**UNITED STATES ENVIRONMENTAL
PROTECTION AGENCY
REGION IX
75 Hawthorne Street
San Francisco, CA 94105**

**STATE OF HAWAII
DEPARTMENT OF HEALTH
P. O. BOX 3378
HONOLULU, HI 96801-3378**

Re: Response to Corrosion and Metal Fatigue Practices, Destructive Testing Results Report, Red Hill Bulk Fuel Storage Facility (Red Hill), Joint Base Pearl Harbor-Hickam, Oahu, Hawaii

Enclosure 1 – Regulatory Agencies’ Interpretation of Destructive Testing Data

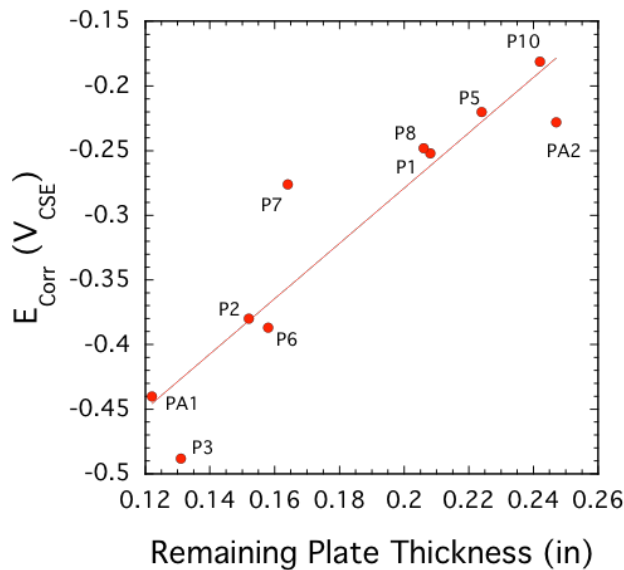
Of the potential measurements corresponding to the back side of the tank wall, only one potential was more positive than -0.2 V_{CSE}, indicating low probability of corrosion; five potentials were in the potential range of -0.20 to -0.35 V_{CSE}, indicating uncertainty of corrosion; and four potentials were more negative than -0.35 V_{CSE}, indicating high likelihood of corrosion. The reported minimum remaining plate thickness values for each plate was plotted vs the corrosion potentials (Figure 5), showing strong correlation. The more negative the corrosion potential (indicating a

higher tendency to corrode), the lower the measured remaining plate thickness. Plates P5, P10, and PA2 corresponding to the three most positive corrosion potentials ($> -0.23 V_{CSE}$) showed no or only very light surface rust (Figure 6) [1]. Plates P1 and P8 (with potentials $\approx -0.25 V_{CSE}$) showed mostly mild surface rust (Figure 6) [1]; whereas, the remaining plates PA1, P2, P3, P6, and P7 (with potentials $< -0.27 V_{CSE}$) showed significantly more severe rusting (Figure 6) [1].

Figure 6: The back side of the steel coupons, structure-to-electrolyte corrosion potentials (in V_{CSE}), and the minimum remaining thickness (in inches) that was measured for each plate. From DT Results Report [1]

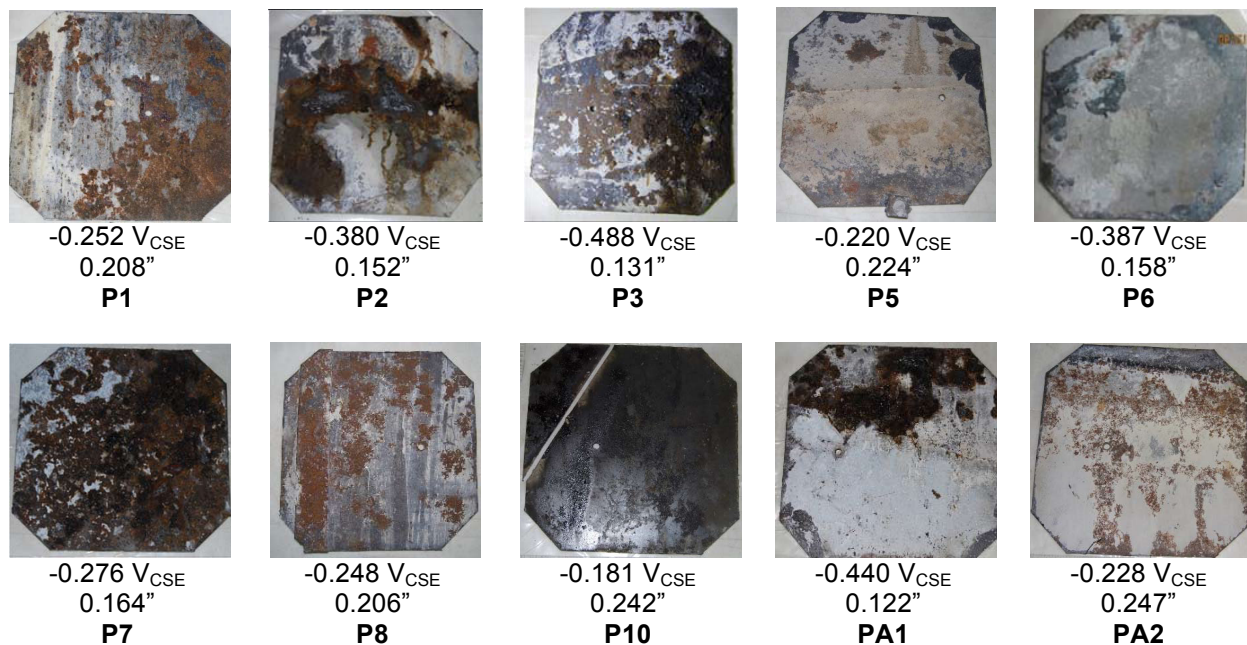
Generally, the formation of the visible red-brown rust (Figure 6) on plain-carbon steel indicates that the passivation in that local region has been lost. The gray regions of the plates (excluding the adhering concrete or grout) are regions where the steel is in the passive state (Figure 6). Passivation can be lost when the pH of the concrete drops below approximately pH 11 [7], or chloride (Cl) ions are present in sufficient concentration [4, 7]. The NACE Standard Practice SP0308-2008 [9] indicates that acid-soluble chlorides in excess of approximately 0.2 % (by weight of cement) can initiate corrosion of steel in concrete. The ion chromatography analyses of the concrete powder samples showed that the chloride concentration in the concrete ranged from 50 ppm (0.005 % by weight of cement) to 171 ppm (0.017 wt%), which is much lower than the threshold. The concentration of chlorides detected in the corrosion

products using energy dispersive X-ray analyses (EDXA), however, was significantly higher: The maximum value of 1.7 wt% (17,000 ppm by weight of corrosion product) was detected in the corrosion product of plate PA1; 0.6 wt% (6,000 ppm) in plates P2 and P7; 0.3 wt% (3,000 ppm) in plates P3, P5, P6, and P10; and none in plates P1, P8, and PA2. The detection limit of EDXA is on the order of 0.1 wt% (1,000 ppm). The maximum concentration of the chlorides in the corrosion products were up to approximately 100 times higher than the maximum concentration in the concrete. Chlorides at these levels as well as the drop in concrete alkalinity below approximately pH 11 are likely to breakdown passivation and cause increasing corrosion rates of the steel.

Figure 11: Cross section of coupon plate P3 (a) at the area of maximum wall loss (p. 18 of DT Results Report [1]) out of four sections examined, and cross section of coupon plate P6 (b) at area of maximum wall loss out of three sections examined (p. 24 of DT Results Report [1])

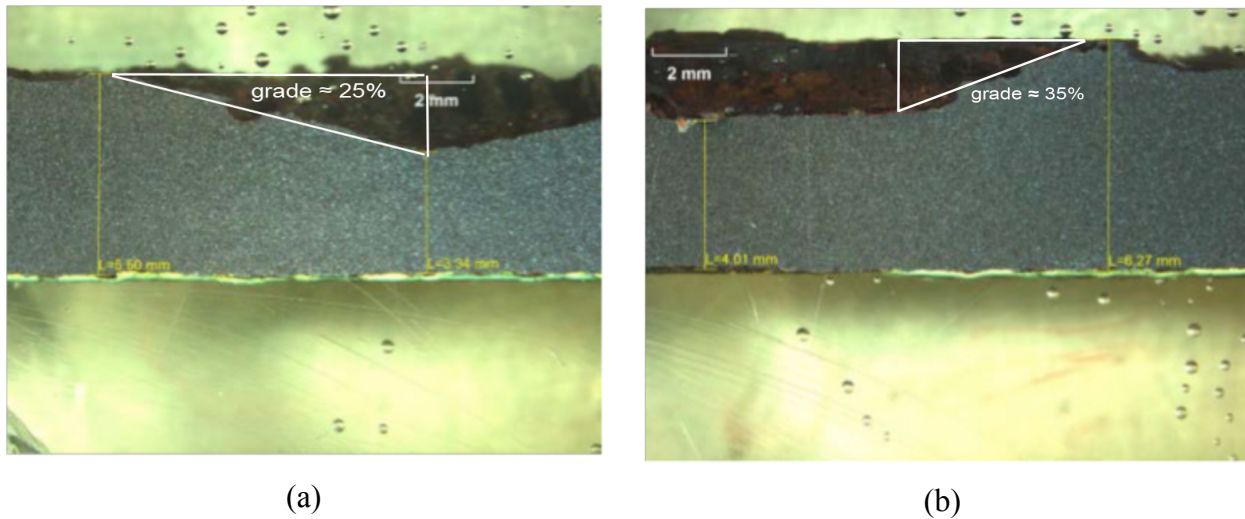
For coupon plates P3 and P6, a remaining thickness less than 0.200" was not expected (pp. 46 and 51 of DT Results Report [1]); however, the destructive testing showed minimum remaining thicknesses of 0.131" and 0.158", respectively, for coupon plates P3 and P6. The pit size and grade (Figure 11) were well within the detectable limits of the low frequency electromagnetic technique (LFET) [16], but these pits were not recorded. The DT Results Report [1] also showed that there were high levels of magnetite in the corrosion products ranging from 17 % to 84 wt% (Table 3). It has been reported in the literature [17] that when

Figure 12: Coupon plate P2. Possible deep pit in yellow box region not sampled. Original images from DT Results Report [1].

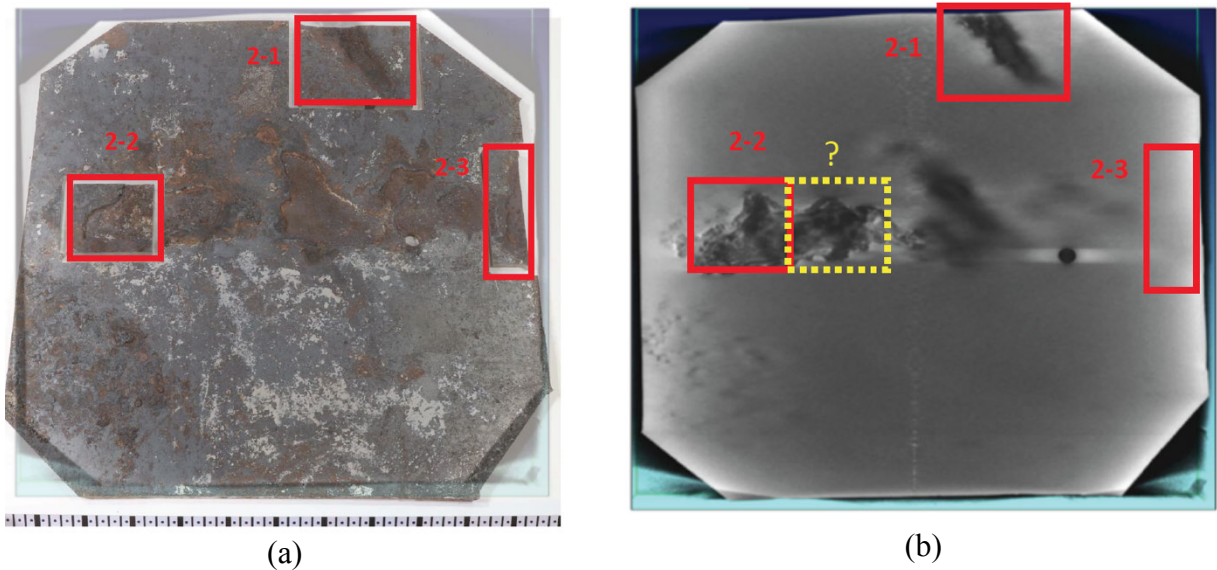
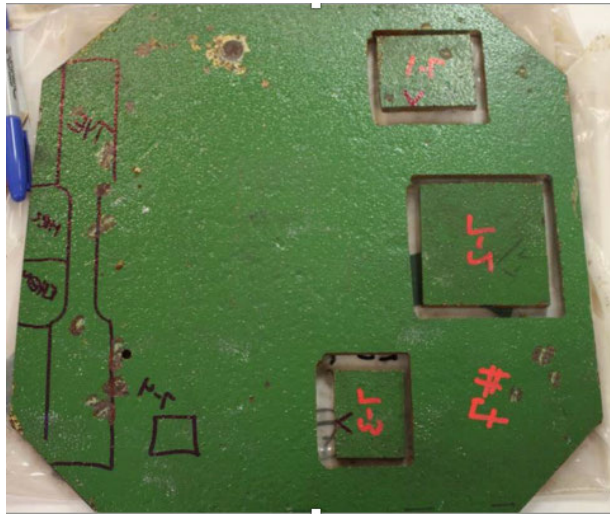
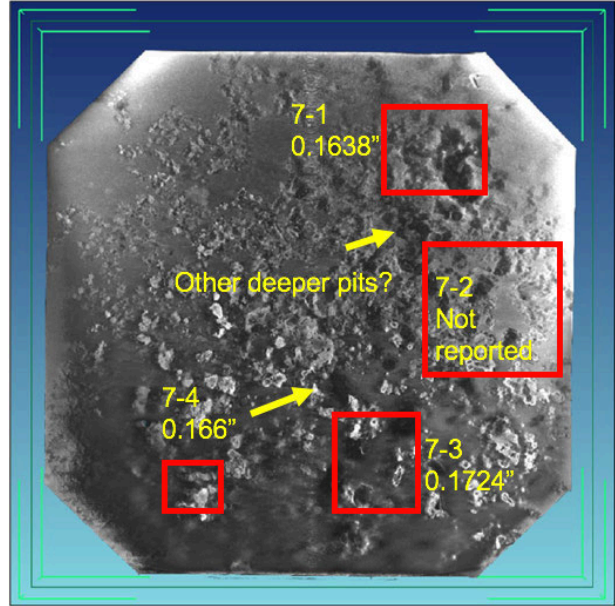
There are also concerns of whether or not the sites with the deepest pits were sampled during the destructive testing. The steel coupons were specified to be cleaned and subjected to three-dimensional profilometry (as specified on p. 8 of the DT Results Report, [1]) to document the

surface profile of the remaining steel substrate. The steel coupons were cleaned with a CO₂ dry ice blast, but all of the corrosion products were not removed; hence, the regions of the deepest pits would be difficult to determine. The three-dimensional profilometry data was not provided in the DT Results Report [1], but the results would likely not have characterized the bare steel substrate since the corrosion products were not thoroughly removed. X-ray computed tomography (CT) was used to aid in selecting the regions with the deepest pits, but in some cases, regions with potential deep pits were apparently not sampled (e.g., Figures 12, 13, and 14). The DT Results Report [1] did not describe if other methods were used to confirm the location of the deepest pits.

Figure 1 – Destructive Testing Cross-section from Sample 6-1

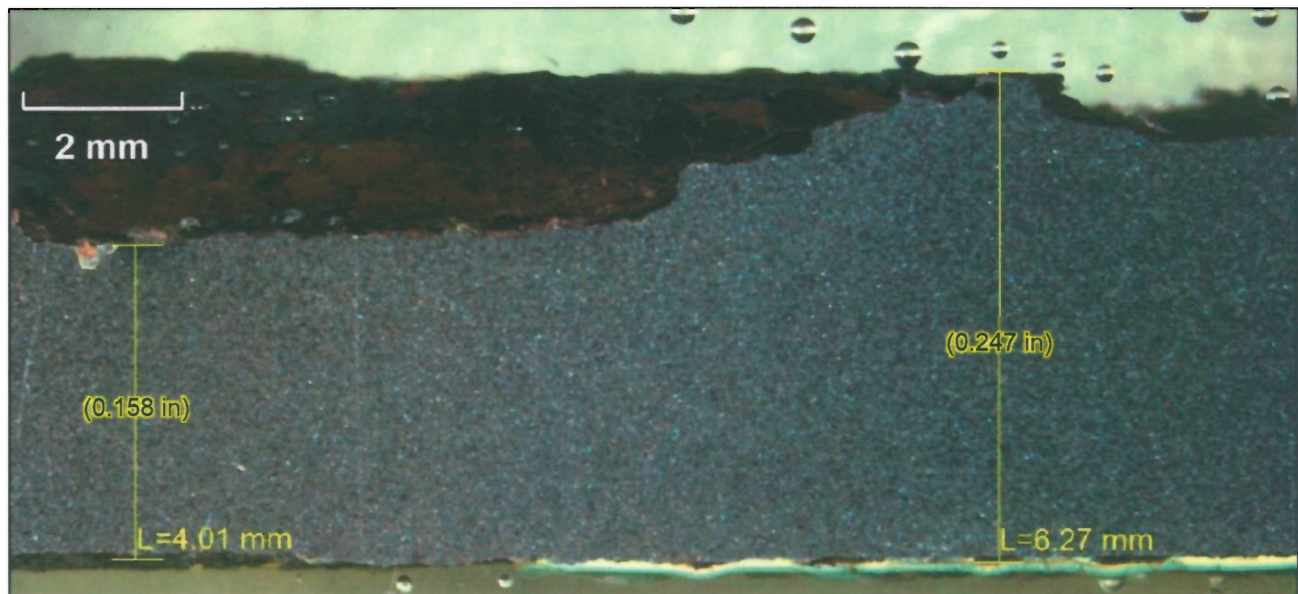
1. The larger, TesTex Falcon Mark II 2000 device should have been able to detect the pit in Coupon 6. According to the Navy this device has a probability of detection (POD) of 100% at 25% wall loss on pits with an aspect ratio of 3:1. The deepest pit in Coupon 6 amounted to ~37% wall loss and aspect ratio of greater than 3:1 (width to depth ratio). Figure 1 shows the cross-section through the deepest pit in Coupon 6 where the size and depth of the pit is obvious.
2. The smaller, TesTex TS-2000 device should have been able to detect the pit in Coupon 6 as the Navy stated this device can detect pits with a diameter of 1.57 mm. The width of the corrosion pit in Coupon 6 was much, much wider than 1.57 mm as is shown in Figure 1.

Second, the BWS believes Figure 1 clearly demonstrates this pit cannot be described as a “*pit of very small volume.*” This figure clearly shows a broad pit of considerable volume.

Figure 2 -- (Image from: IMR Test Labs. 2018)

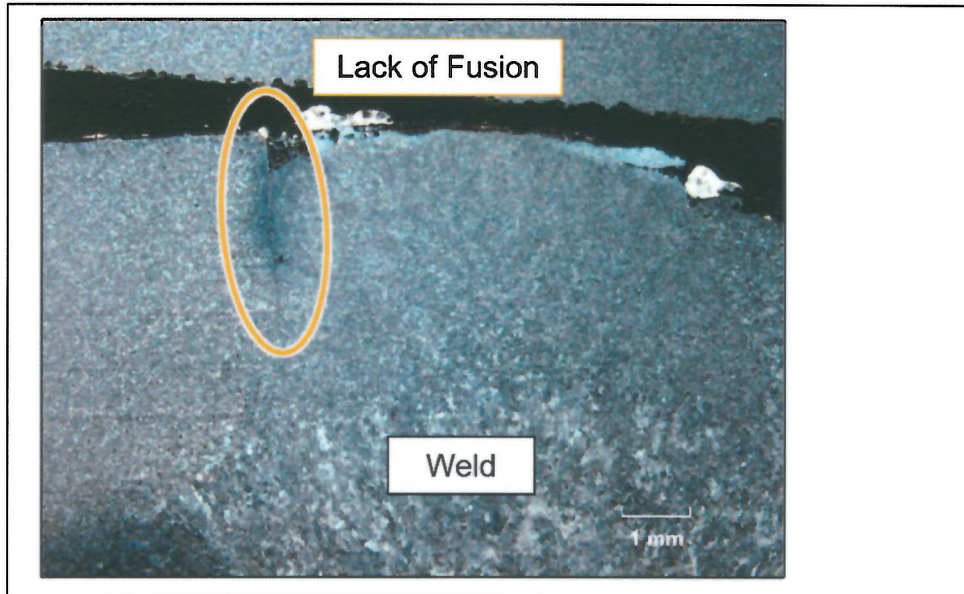
4. The DT inspection did find weld defects. The one coupon that actually had a weld contained a linear defect that was found by destructive testing. This lack of fusion linear weld defect is shown below.

Figure 4 – Relationship between NDE thickness estimate prior to DT and the actual remaining thickness determined from DT.

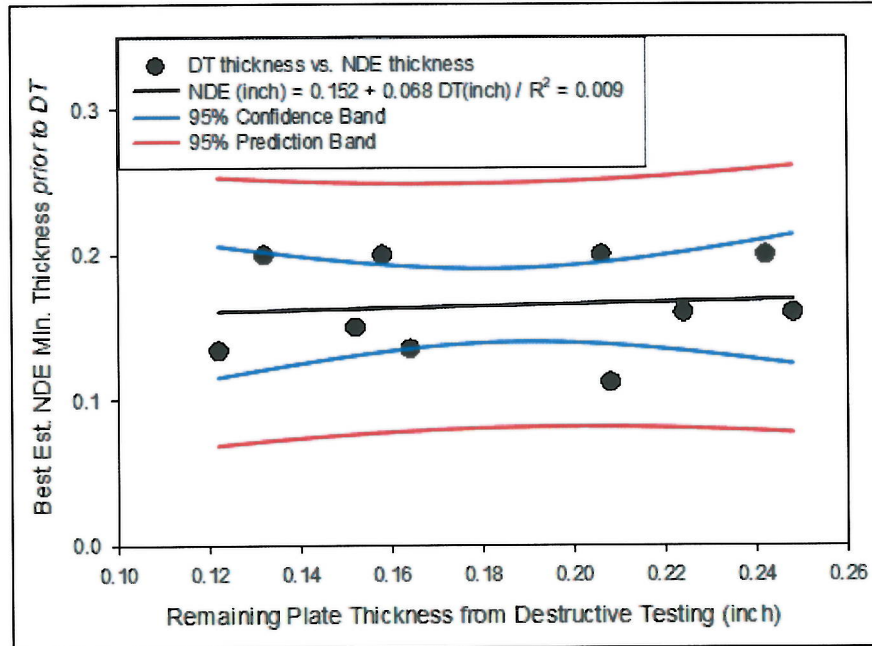
Figure 4 clearly indicates the NDE techniques are neither accurate nor reliable. First, the slope (0.068) of the line drawn through the DT vs NDE data is very flat (close to zero), indicating the NDE results are essentially insensitive to actual corrosion depth. For comparison, if NDE was perfectly accurate, then the DT thickness would be equal to the NDE thickness and the slope of the line drawn through the data would be 1.0. Instead, the calculated slope is consistent with what one would expect if the NDE results were simply chosen at random without regard to the actual coupon thickness. Another indication is the coefficient of determination (R^2), which measures NDE accuracy by comparing the variation in NDE results to the residual variation after accounting for the actual coupon thickness (using the regression line). As noted in Figure 4, the R^2 value is effectively zero (0.009), indicating none of the observed variation in NDE-measured thickness is attributable to corresponding variation in the actual thickness of the test coupons.

Finally, the figure includes plots of the 95% lower and upper prediction bands, which are very broad. For example, for a coupon with an actual remaining wall thickness of 0.12 inch, with 95% probability the corresponding NDE-measured thickness will fall between 0.070 and 0.25 inch (the values at which the lower and upper bands, respectively, intersect the vertical line at 0.12 inch). The bands vary little over the range of coupon thickness studied. Thus, for any actual tank wall thickness, the NDE-measured thickness can be reasonably expected to range from effectively no damage to severe damage.

Figure 5 – Destructive Testing Cross-section from Sample 3-3.

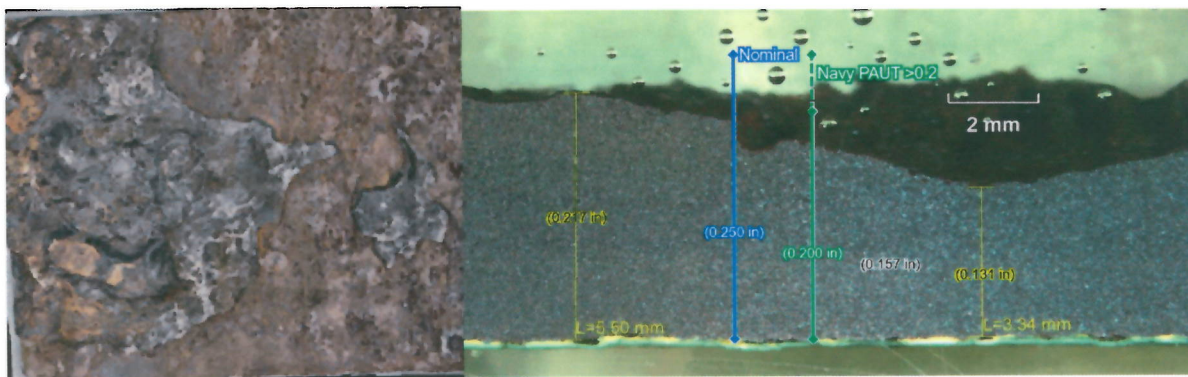
A more graphic illustration of the error in the NDE methodology is shown in Figure 5. The image on the left-hand side of Figure 5 shows the extensive backside corrosion on Coupon 3. The right-hand side of Figure 5 shows the plate's reported thinnest area in cross-section after destructively testing. While it is unclear from the DT and IMR reports, this thinned region

(0.131-inch-thick) was presumably located by CT scanning of the entire coupon. The Navy NDE predicted that this area had little to no backside corrosion.

The thin blue-green layer on the bottom of the plate on the right-hand side of Figure 5 is the paint on the fuel wetted side of the steel liner. The blue line shows the full plate thickness of 0.250 inches. The yellow line on the left side is the actual maximum plate thickness which shows 0.217 inches thickness indicating general corrosion thinning and deeper corrosion over the back side of this steel coupon. The green line shows the thickness the PAUT found, i.e., > 0.200 inches (LFET found a remaining wall of 0.033 inches but the supposedly more accurate PAUT indicated the plate was much thicker). The actual minimum thickness found by DT was 0.131-inches as shown by the yellow line on the right side. This variation in the lengths of the colored lines illustrates how large the difference can be between the various NDE inspection techniques and the actual depth of corrosion. In this case, LFET indicated the plate was very thin, the PAUT prove-up indicated little-to-no corrosion, and the DT indicated that this location was sufficiently thinned that repair should have been triggered.

Figure A-5. The same area is shown in an image provided prior to shipping Coupon #7 to IMR (provided to IMR on March 13, 2019). What appeared to be a deep corrosion pit was actually rust-colored staining of the edge surface

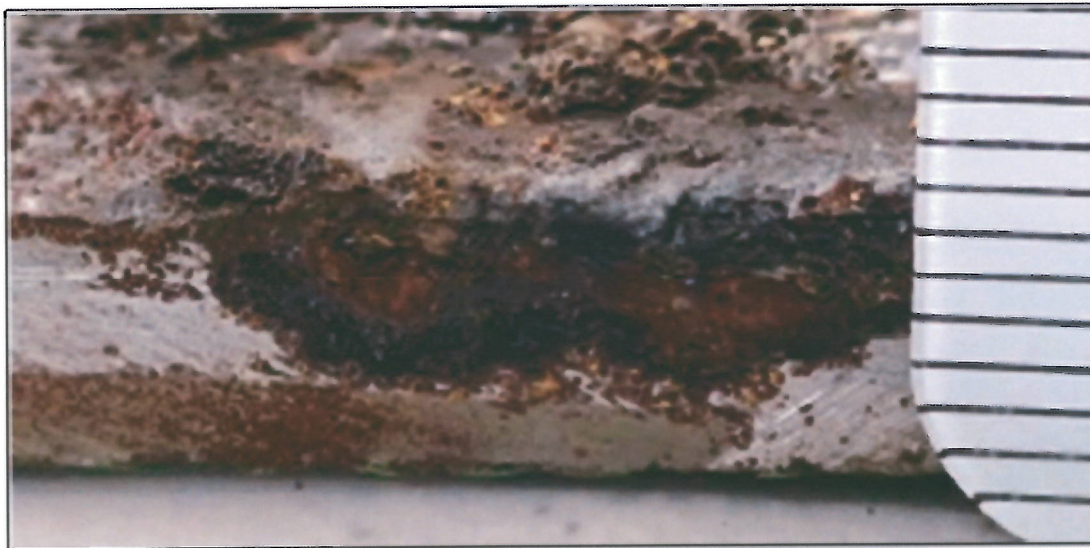
Following the initial issue of IMR on December 17, 2018, the Navy asked IMR to further investigate the corrosion seen on the edge on the remains of Coupon #7. IMR used CO₂ cleaning of the test sample edge. These results are provided in Appendix A of the IMR revised report. Figures A-4 and A-5 of the IMR revised report are included below to show the area of concern. The revised report Appendix A concludes:

1. There was pitting observed as shown in their Figure A-4
2. It is not surprising that corrosion was not found as this area had been sandblasted.
3. The explanation that the area of concern "had been superficially altered by heat associated with sectioning or some other post-sectioning reaction (atmospheric corrosion or corrosive media attack)" is not credible. Atmospheric corrosion would be uniformly distributed along the cut surface, but the area of concern is localized. Secondly, the porosity is not consistent with heat associated with sectioning. Finally, we are unaware of any corrosive media used during coupon removal that could have locally attacked the edge in the area of concern.
